Comment Summaries: 93A, Cross-clause editorial, TP0v

IEEE P802.3ck Task Force

October 19,2020

Figure 163A-1—Measurement method for transmitter reference steady-state voltage, pulse peak and ERL

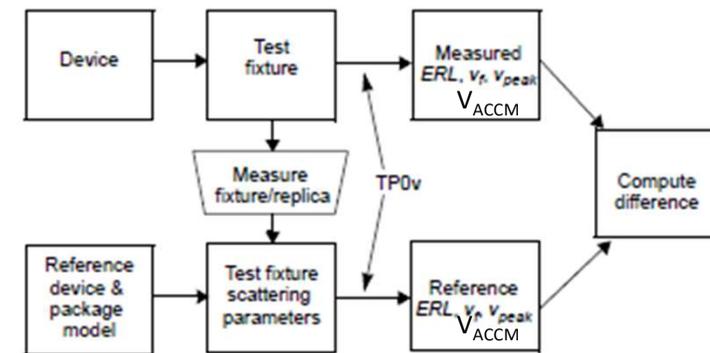
By adopting "TP0v" test fixture methodology, not only ERL, v_f , v_{peak} , but also AC common-mode RMS voltage shall be scaled by IL of TP0v test fixture.

If we take the V_{ACCM} as the notation for "AC common-mode RMS voltage", propose to change the blocks of "Measured ERL, V_f , V_{peak} " & "Reference ERL, V_f , V_{peak} " in Figure 163A-1 to "Measured ERL, V_f , V_{peak} , V_{ACCM} " & "Reference ERL, V_f , V_{peak} , V_{ACCM} ".

PROPOSED REJECT.

The proposed remedy is not sufficiently complete to implement.

Figure 163A-1—Measurement method for transmitter reference steady-state voltage, pulse peak and ERL

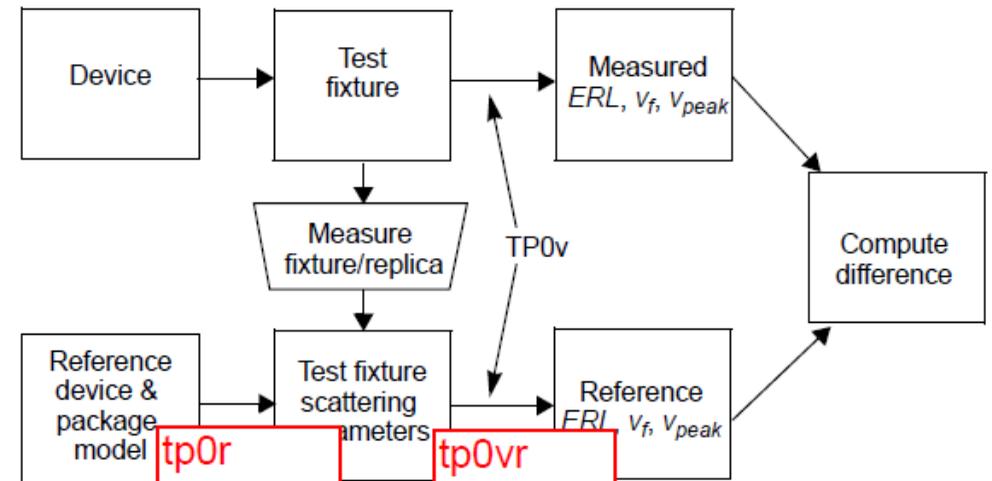
TP0 is the interface between Transmitter package ball and PCB as shown in Figure 163-3. TP0 is not stable for measurement, because TP0 is highly non-TEM mode. A replica test fixture may have a test point corresponding to TP0, but this cannot be exactly same as TP0 due to the difficulty of measurement at TP0. In order to remind this difference, we should make the label of the test point for replica test fixture different from TP0. We should not assume replica test fixture is same as actual test fixture. Also for clarification, I suppose we should differentiate the label of TP0v between the test fixture attached to DUT and the replica test fixture.

Use TP0r and TP0vr as the labels for the test points where the replica test fixture may be used.

PROPOSED REJECT.

Defining different test point labels is not necessary or helpful. The suggested remedy does not add clarity to the specification.

Figure 163A-2—Configuration for transmitter reference steady-state voltage, pulse peak and ERL

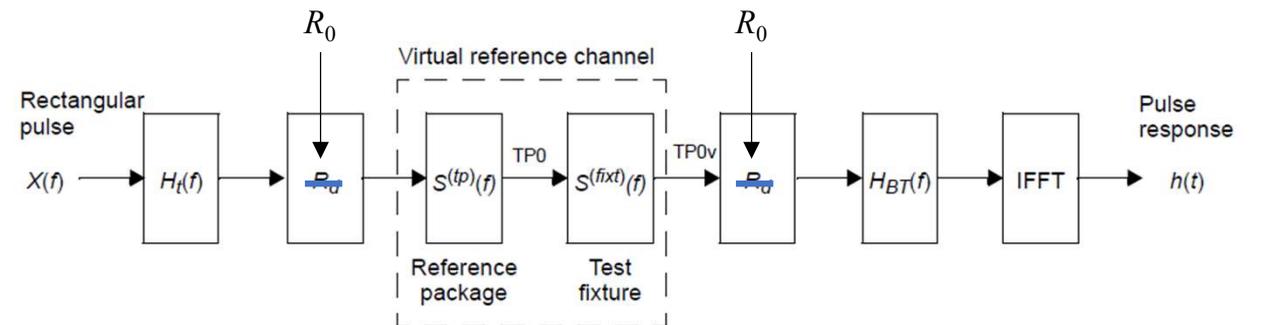
In Figure 163A-2, termination resistance at TP0v should represent an instrument and not a device (i.e., it should be the reference resistance R_0 and not the device resistance R_d).

Replace "R_0" with "R_d".

PROPOSED ACCEPT IN PRINCIPLE.

Implement the suggested remedy with editorial license.

Figure 163A-2—Configuration for transmitter reference steady-state voltage, pulse peak and ERL

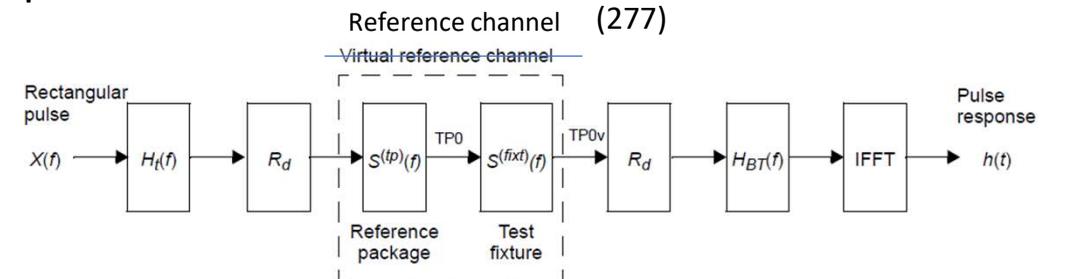
I don't like the term "virtual reference channel". It's no more unreal than the other blocks in this figure. I didn't find any other "reference channel" in this draft.

Change its name to "reference channel" or "reference test channel" throughout.

The material in the NOTE needs to be normative.

Move it to regular text at line 42

PROPOSED ACCEPT IN PRINCIPLE.

Implement the suggested remedy with editorial license.

PROPOSED ACCEPT IN PRINCIPLE.

Implement the suggested remedy with editorial license.

Note: The transmitter reference package uses the maximum length specified by the clause that invokes this method.
